UNITED STATES
DEPARTMENT OF THE INTERIOR
BUREAU OF LAND MANAGEMENT

SUNDRY NOTICES AND REPORTS ON WELLS

Hudson 1 Federal #9H

BOPCO requests approval for the revised horizontal casing program.

Plot reference wellpath is Plan #3

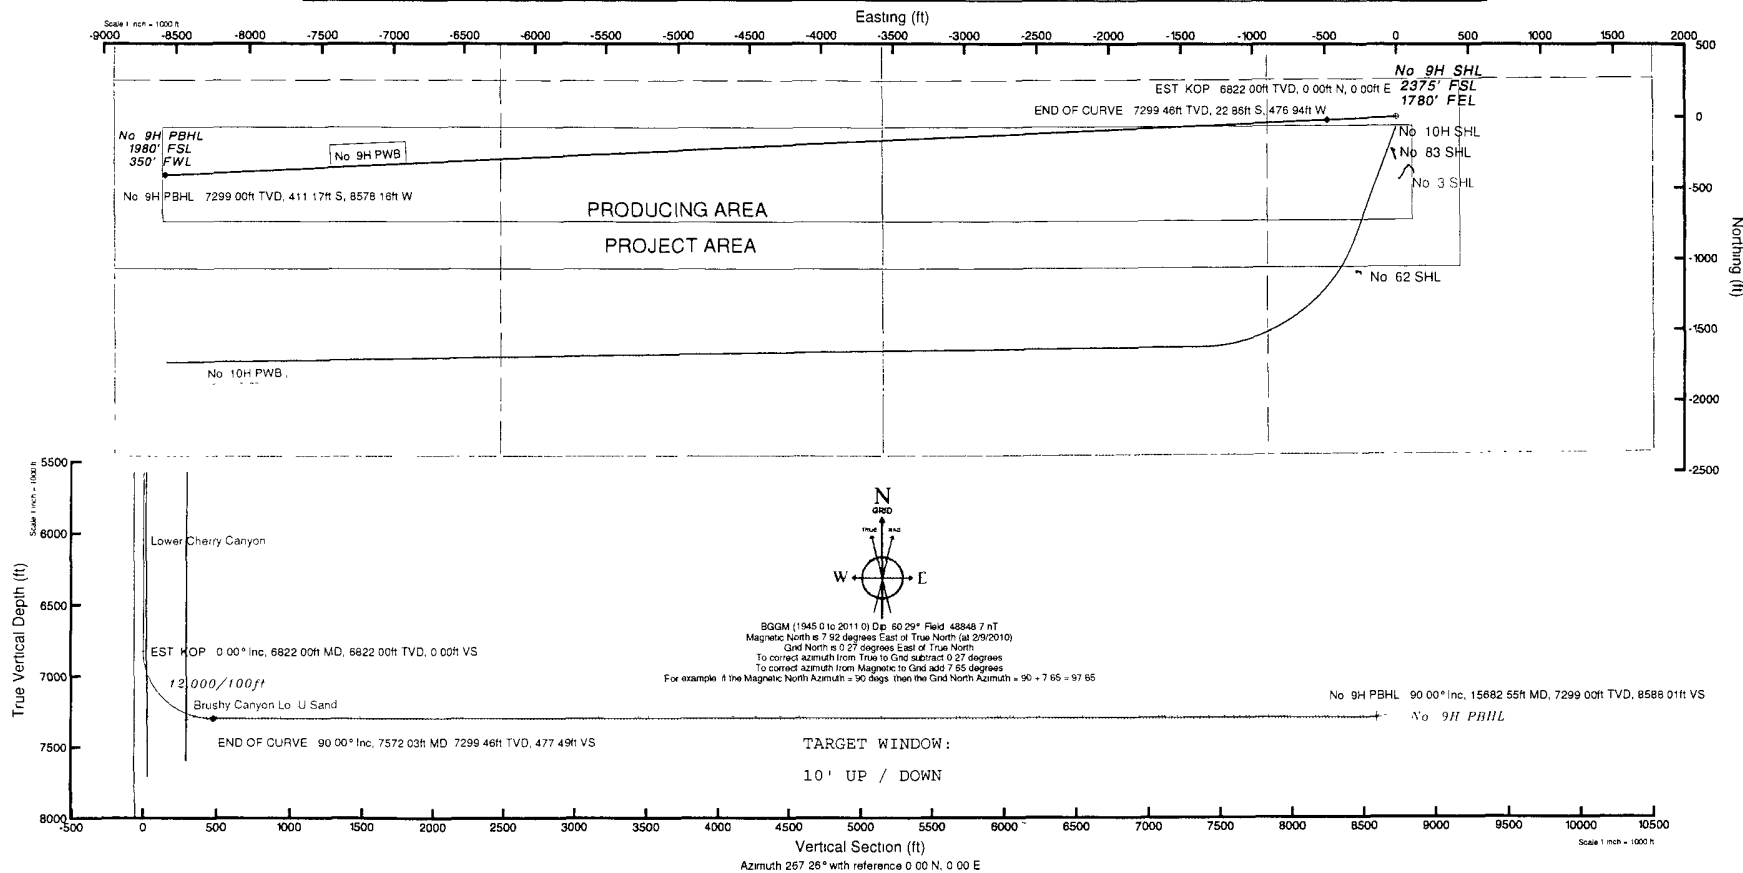
The 7" casing program will be changed from 7855' of 7", 26#, P-110, LT&C to 7823' of 7", 26#, P-110, LT&C.

The 4-1/2" casing program will also be changed from 8008' of 4-1/2", 11.6#, P-110, LT&C with Baker packers for isolation and the liner hanger will be set at approximately 7705' to 8010' of 4-1/2", 11.6#, P-110, LT&C with Baker packers for isolation and the liner hanger will be set at approximately 7673'.

The revised horizontal drilling plan is attached.
